**RE: JMC Project 14088
Hudson Ridge Wellness Center
2016 Quaker Ridge Road
Town of Cortland, NY 10567
Response to Landscape Comments for Site Plan Review**

SITE LANDSCAPE PLAN
PROPOSED SPECIALTY HOSPITAL
TOWN OF CORTLAND, NEW YORK

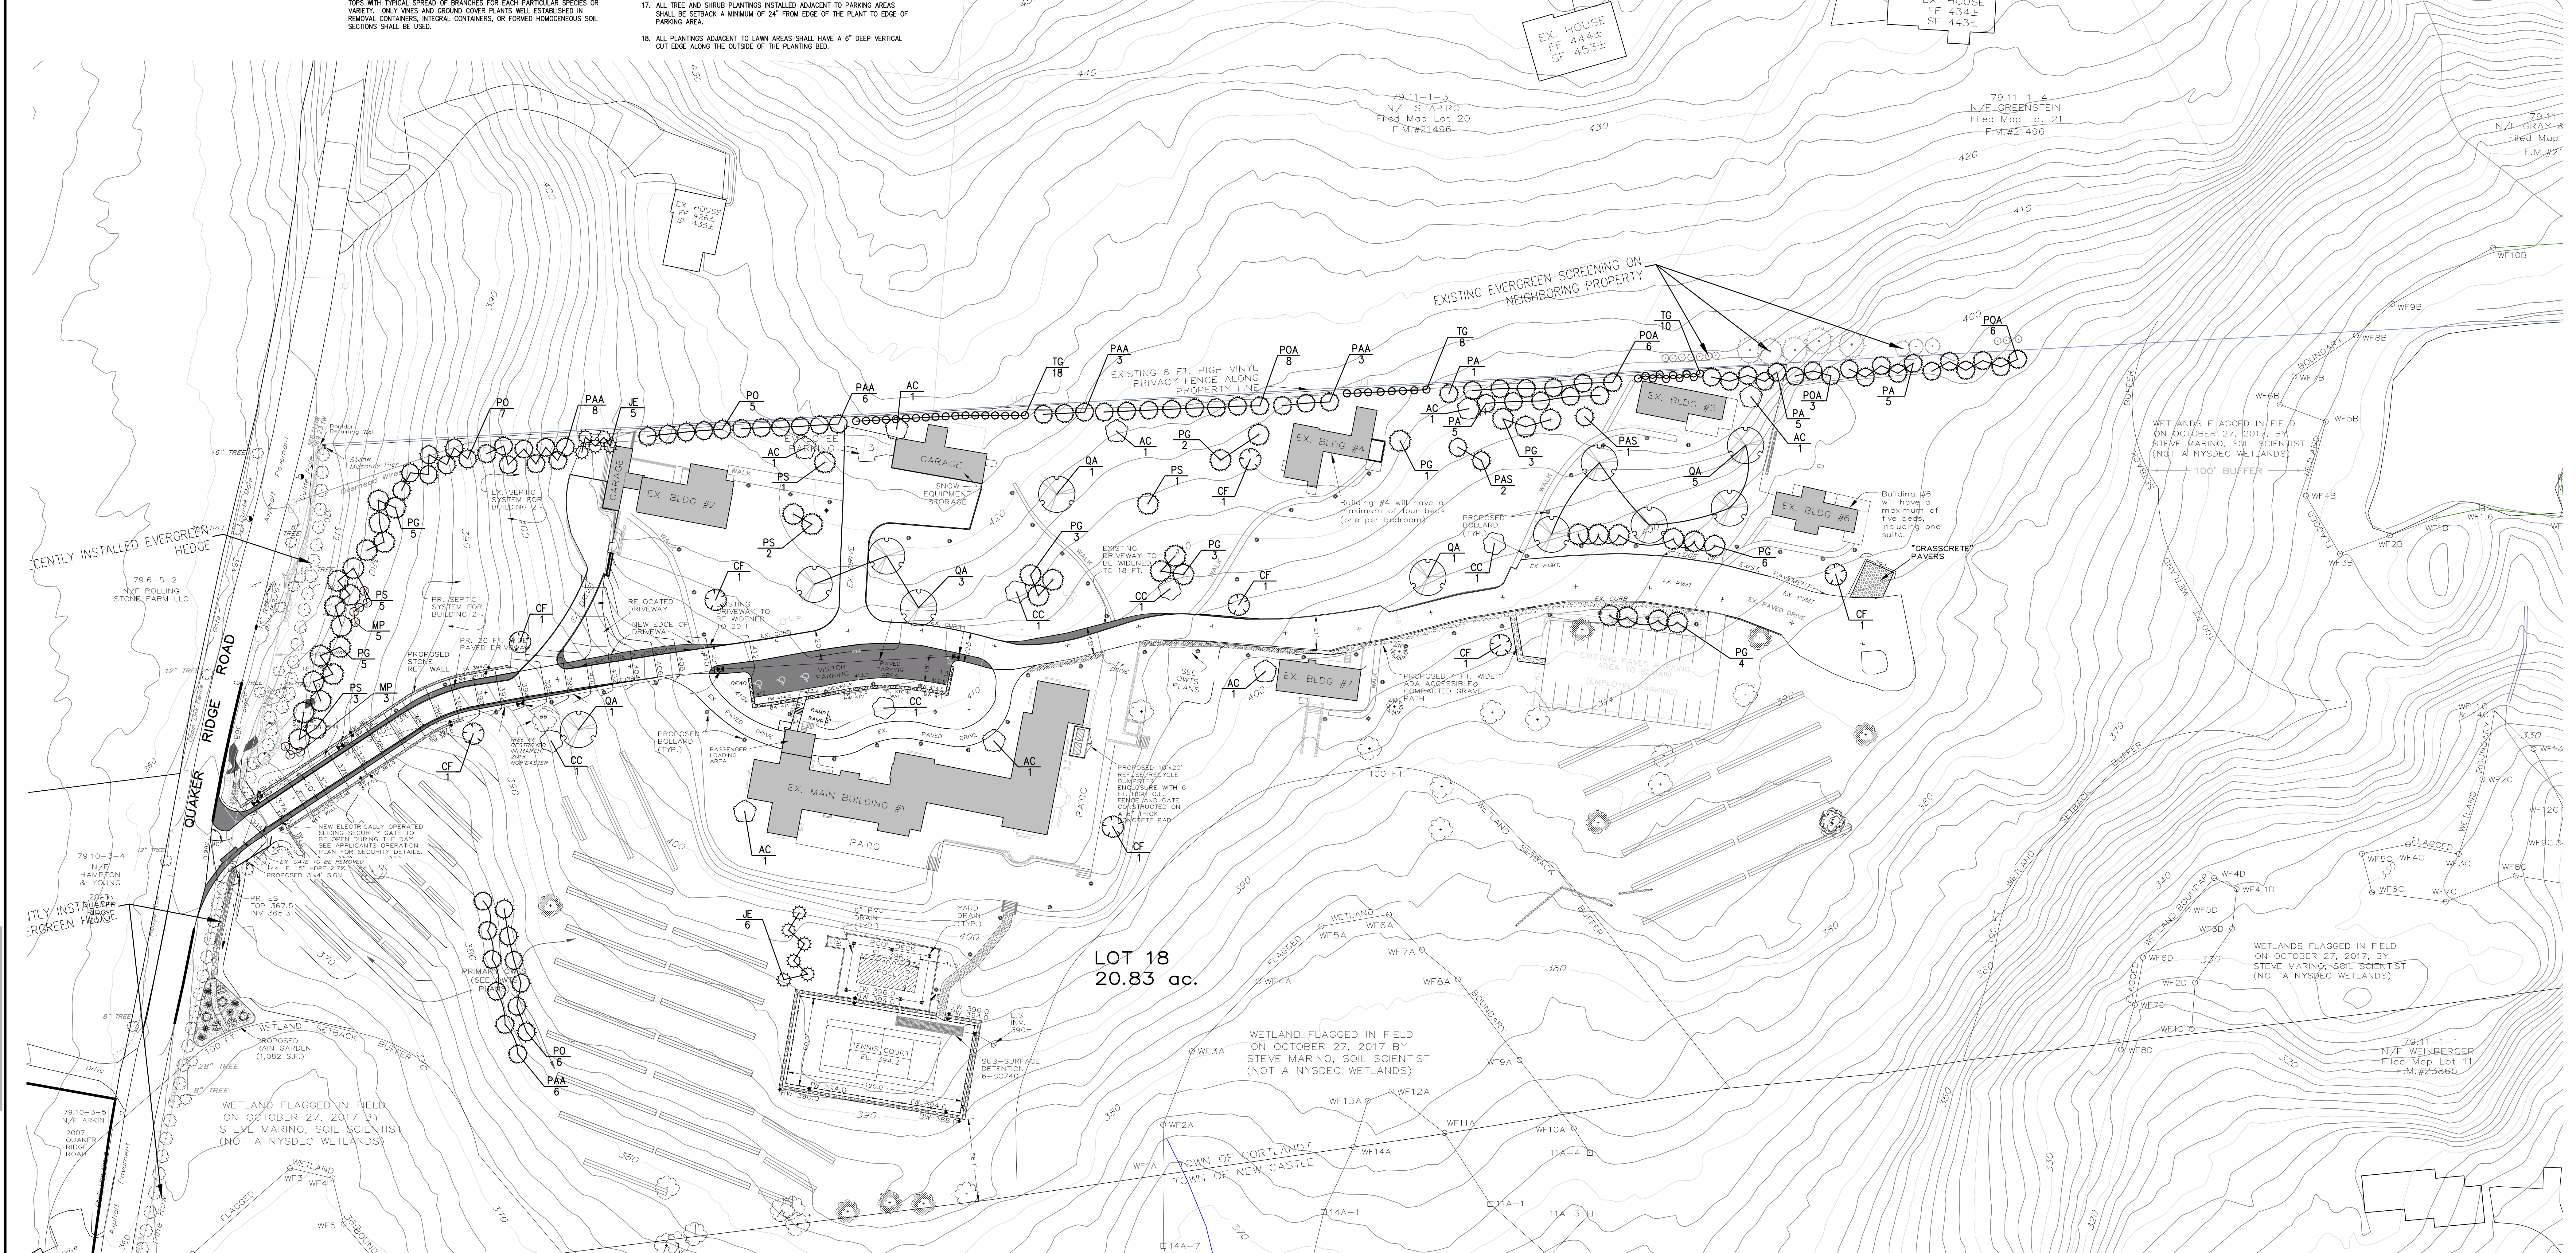
- a. If they are going to use White Pines as screen trees, they should plant large evergreen shrubs or small ever green trees in front of them or behind them so that when the white pines start shedding their lower branches there will still be screening.***

- b. Can they swap out the Spruces they are proposing for Native evergreens such as White Spruce, Eastern Red Cedars, American Holly?***

- c. Can they propose an alternative to Green Giant Arborvitae. While this is considered more deer resistant to others in a cold winter the deer will eat the bottom half of the plant if there is no other food source.***

- d. Could the plan accommodate a few more trees that provide a habitat for birds/butterflies and a little "less boring" overall.***

Of the (12) Pines specified (8) are along the road area just behind the existing arborviate hedge. In this area as the pines lose their lower branches, visibility into the site will still be screened as there is an existing arborviate hedge closer to the road. We have; however, placed an additional (8) shrubs at the base of the pines to

accommodate lower branch loss. The other (4) pines are interior to the site and do not require additional plantings because the loss of their lower branches does not have an impact on screening as they are interior to the site.

The proposed Norway spruce and Serbian spruces while not native, are very well-behaved non-natives that do not spread as invasive species do. They were chosen for their quick growth rates, dense habit, and disease resistance. We have switched some of the spruces to white spruces wherever practical but not along the northern property line because the Landscape Plan along the northern property line reflects the desires and concerns of the adjacent neighbors. The American Holly and Cedars are very slow growing, so we did not use them in this area.

In lieu of some of the Arborvitae within the site we switched them out to the Eastern Red Cedar, again where we thought they would work best.

The arborviate has been proposed primarily along the northern property line/fence line. The fence will serve to protect the Arborviate along the fence, and it is our recommendation to our client that they either "burlap" the bottom of the fence or spray the fence with deer repellent prior to the winter season. Again, the arborvitae has been chosen for the fast growth, density, and disease resistance, and requested by several of the neighbors.

the environmental habitat enhancements. The revised plan includes (21) native flowering trees (Dogwoods, Shadblows and Redbuds).
